ORDINANCE 00-26

TO AMEND THE PRELIMINARY PLAN FOR THE GOLF COURSE COMMUNITY PLANNED UNIT DEVELOPMENT
Re: 1000 West Gordon Pike
(Richland Construction, LLC, Petitioner)

Subject: Case # PUD-14-00

BLOOMINGTON PLAN COMMISSION
PRELIMINARY REPORT
LOCATION: 1000 West Gordon Pike

PUD-14-00
Entry Detail
Showing Use of Existing
Mill Blocks

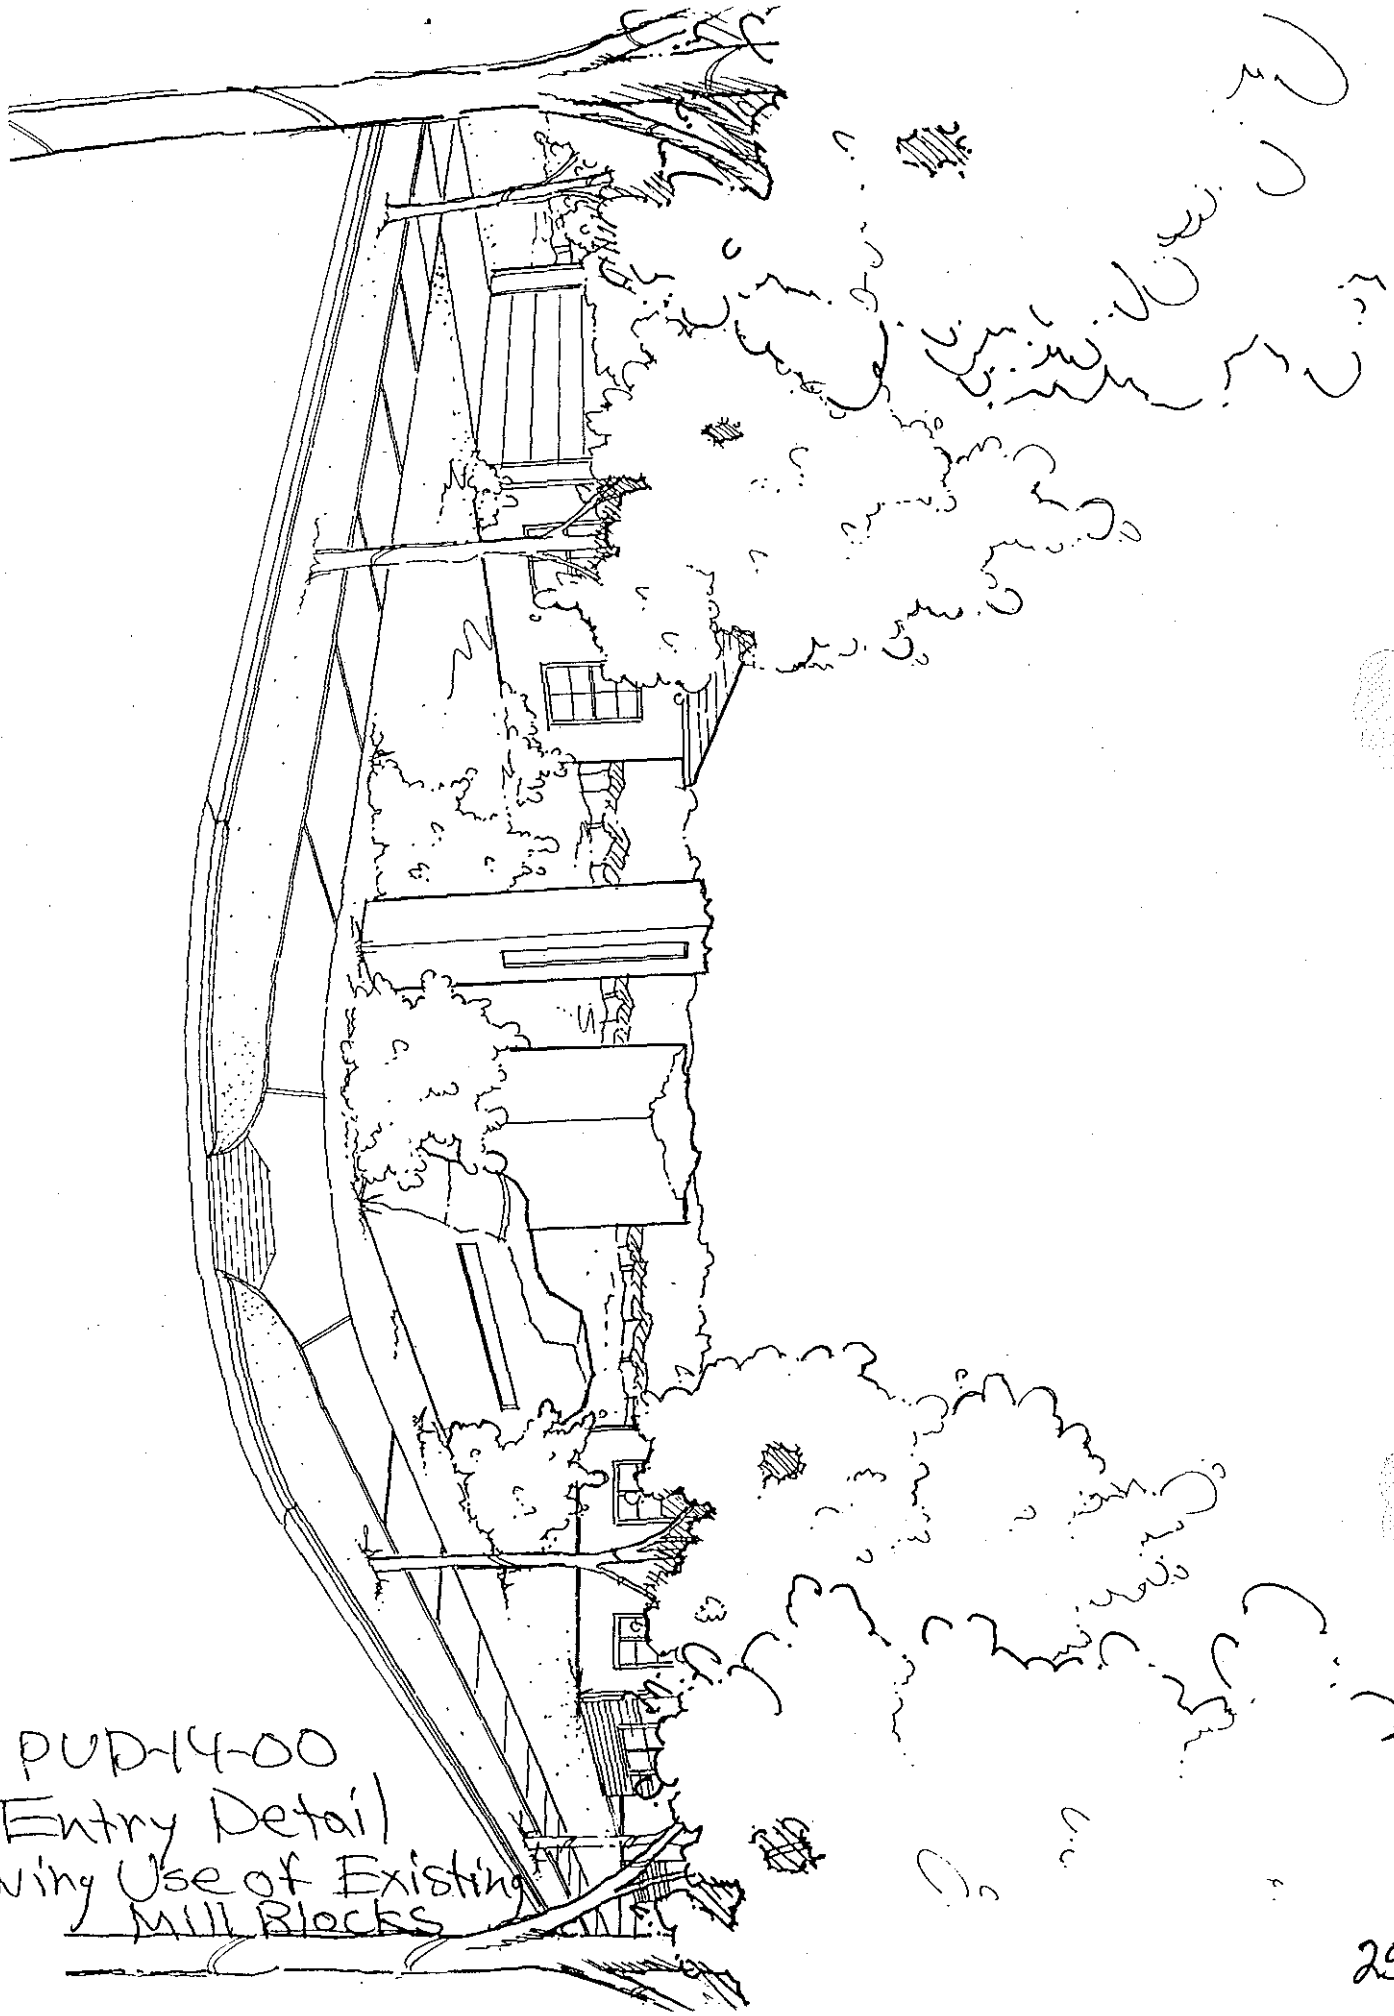
4. Decorative features to enhance the proposed neighborhood: I have enclosed an intersection detail depicting the use of the natural features of this site to create a common theme for this project. These features will consist of utilizing the Mill Blocks located on site as well as additional landscaping to create interesting focal points throughout the property. These will be used to compliment the features to be provided in the round a bouts.

9. As a component of the PUD's subdivision design, the petitioner shall incorporate the use of corner landscaping, roundabout landscaping, millblock features, and integrated signage elements consistent with the petitioner's statement and exhibits.
